Work Order ID 108251

Item Name: Aft Crosstube - High

DRAWING NO. D212-664-241	TITLE CROSSTUBE ASSY (205/212 HI AFT)	REV. D	DART AEROSPACE LTD ENGINEERING ORDER		D.E.O. NO. D212-664-241-D-1	SHEET NO. SHEET 1 OF 2	SCALE NTS
DRAWN	CHECKED	MFG. APPR.	APPROVED	DE APPR.			
DATE 11.04.07	DATE 11.04.11	DATE 11.04.12	DATE 11/04/12	DATE 11.04.12

FIGURE 1: SUPPORT INSTALLATION

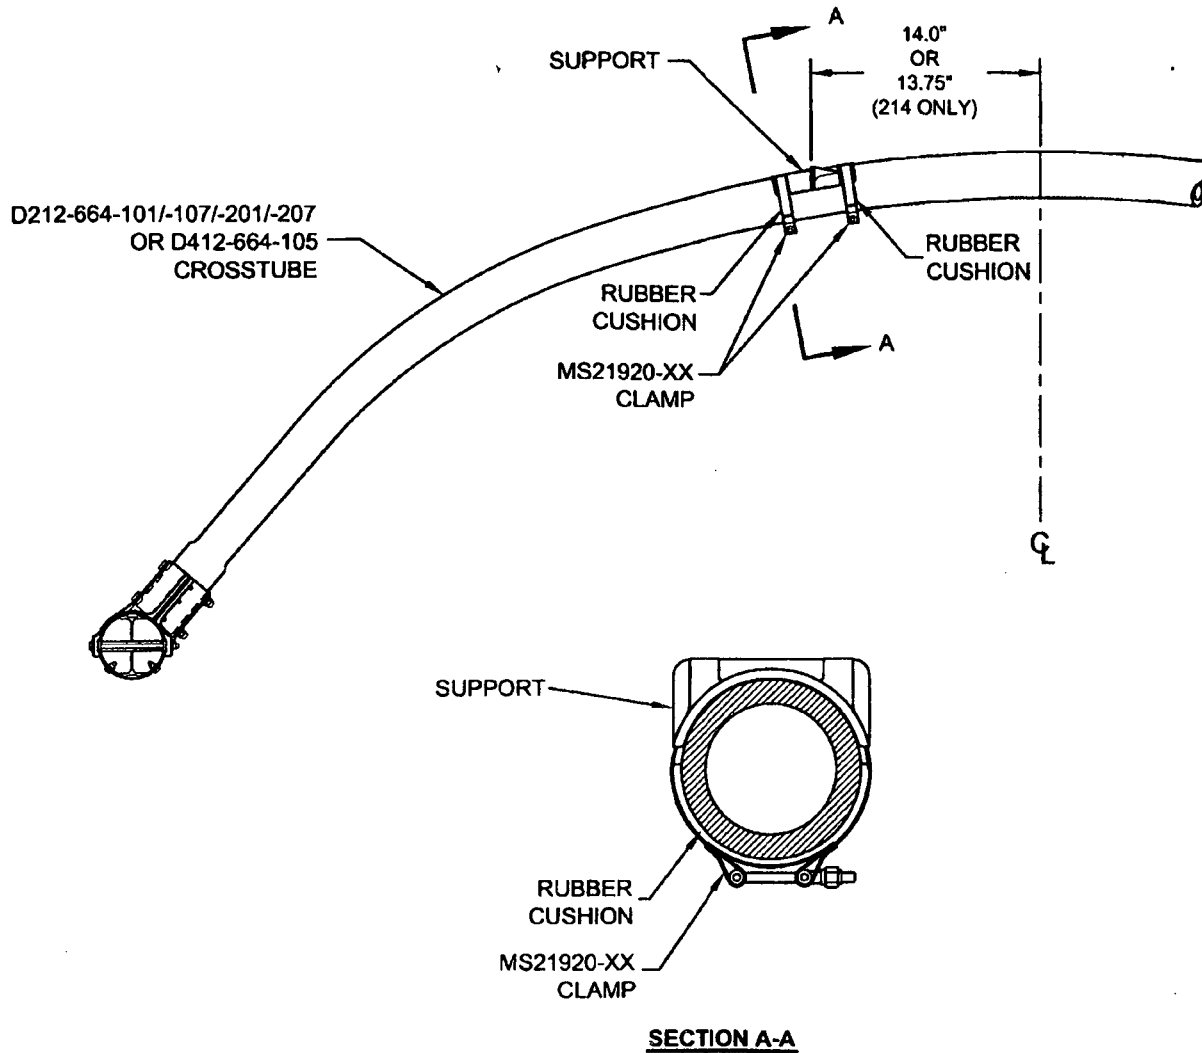
For the crosstubes listed above, section 32.4 of ICA-D212-664 is amended as follows. Use Figure 1 of this service instruction and Figures 32-2 to 32-9 of ICA-D212-664 for further reference. For crosstubes of an earlier change number, it is recommended that if the supports are removed, the supports should be reinstalled using the procedure listed below.

- 32.4.1 Locate the area on the crosstube for installation of support (see Figure 1 of this service instruction). For D212-664-101/-107/-201/-207 and D412-664-105 crosstubes, the outward face of the support tabs should be 14.0" (355mm) from the crosstube center for 204/205/210/412/UH-1 aircraft. For installation on 214B/B-1 aircraft, the outward face of the support tabs should be 13.75" (349mm). Ensure paint finish of crosstube is intact; touch up as required per Chapter 5 (5.3.9) of ICA-D212-664.

- 32.4.5 Apply a 0.04" to 0.07" thick layer of Proseal 890 Class B or AMS-S-8802 Class B sealant underneath applicable support and install support as shown in Figure 1 of this service instruction.

- 32.4.6 Install the clamps opposite to crosstube support as shown in section A-A of Figure 1. Install rubber cushions underneath each clamp around the bottom circumference of the crosstube up to the crosstube centerline. Torque clamps 80-100 in-lb (9.0-11.3 Nm). It is acceptable to use smaller or larger sized MS21920-XX clamps than those listed in ICA-D212-664, ensure that after torquing the clamps per this instruction, the nuts are in safety but not bottomed out

D212-664-241/-241B
ASSEMBLY DETAIL D

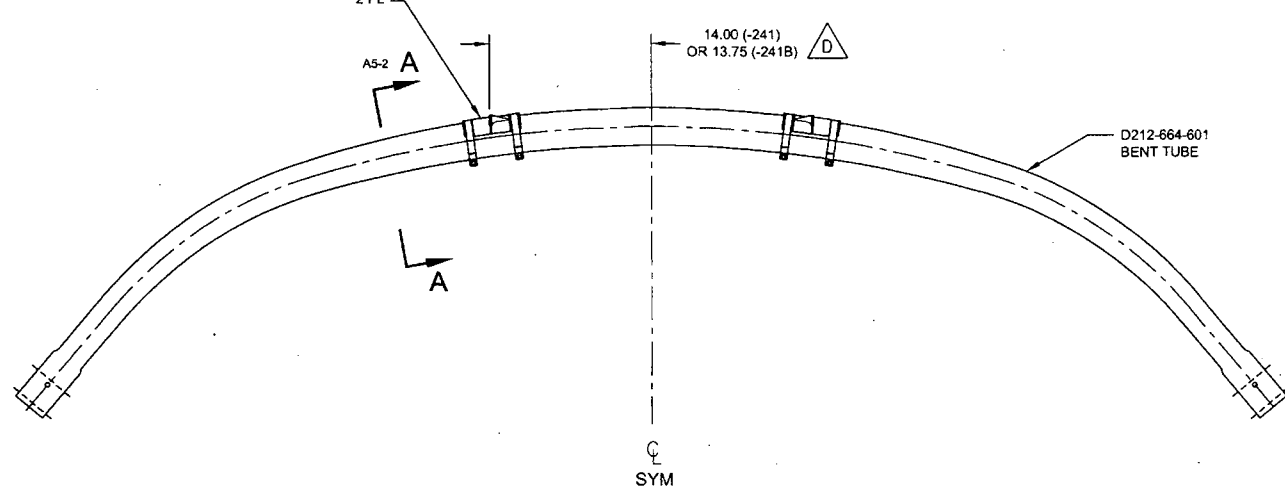
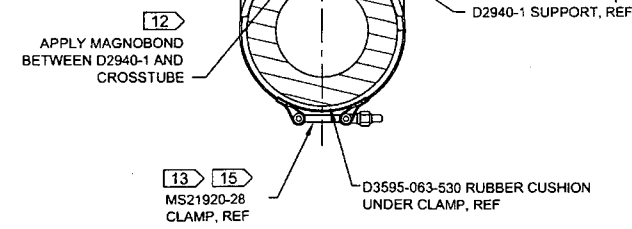
REPLACE MAGNOBOND WITH PROSEAL.

- 12) TO INSTALL D2940-1 SUPPORT: ABRABE MATING SURFACE OF SUPPORT AND CROSSTUBE WITH 180-GRIT SANDPAPER AND REMOVE RESIDUE WITH MEK (OR EQUIVALENT). APPLY A 0.04" TO 0.07" THICK LAYER OF PROSEAL 890 CLASS B-2 (OR AMS-S-8802 CLASS B-2) SEALANT TO MATING SURFACE OF SUPPORT.
- 15) TORQUE CLAMPS 80 TO 100 IN-LB. ENSURE AT LEAST 1.5 THREADS SHOWING IN SAFETY AND THAT NUT HAS NOT BOTTOMED-OUT AFTER TORQUING. **PRIOR TO PACKAGING, RE-CHECK TORQUE ON CLAMPS AFTER PROSEAL 890 SEALANT HAS CURED FOR 72 HOURS.**

D212-664-241/-241B
ASSEMBLY DETAIL

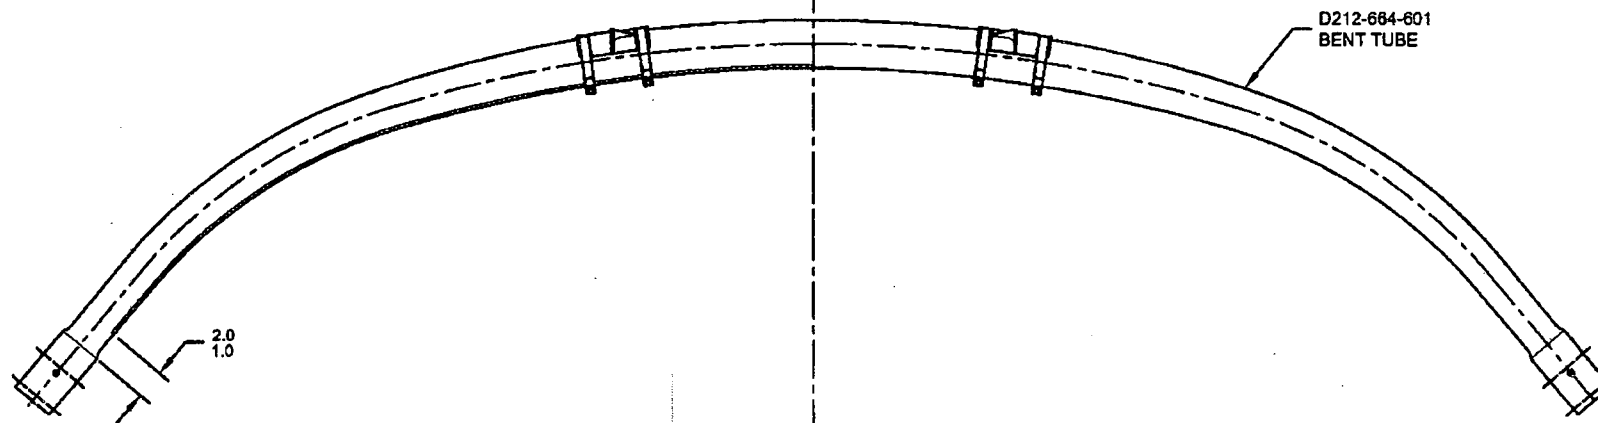
ADD AN INSPECTION WINDOW TO UNDERSIDE OF CROSSTUBE.

- 2) FINISH: CHEMICAL CONVERSION COAT PER DART QSI 005 4.1
PRIME INSIDE AND OUTSIDE PER DART QSI 005 4.2
MASK UNDERSIDE OF CROSSTUBE AS SHOWN (HATCHED AREA) AND
PAINT OUTSIDE PER DART QSI 005 4.2
REMOVE MASKING AND APPLY CLEAR COAT

MASK AREA PRIOR TO PAINTING,
REMOVE MASKING AFTER PAINT
AND APPLY CLEAR COAT
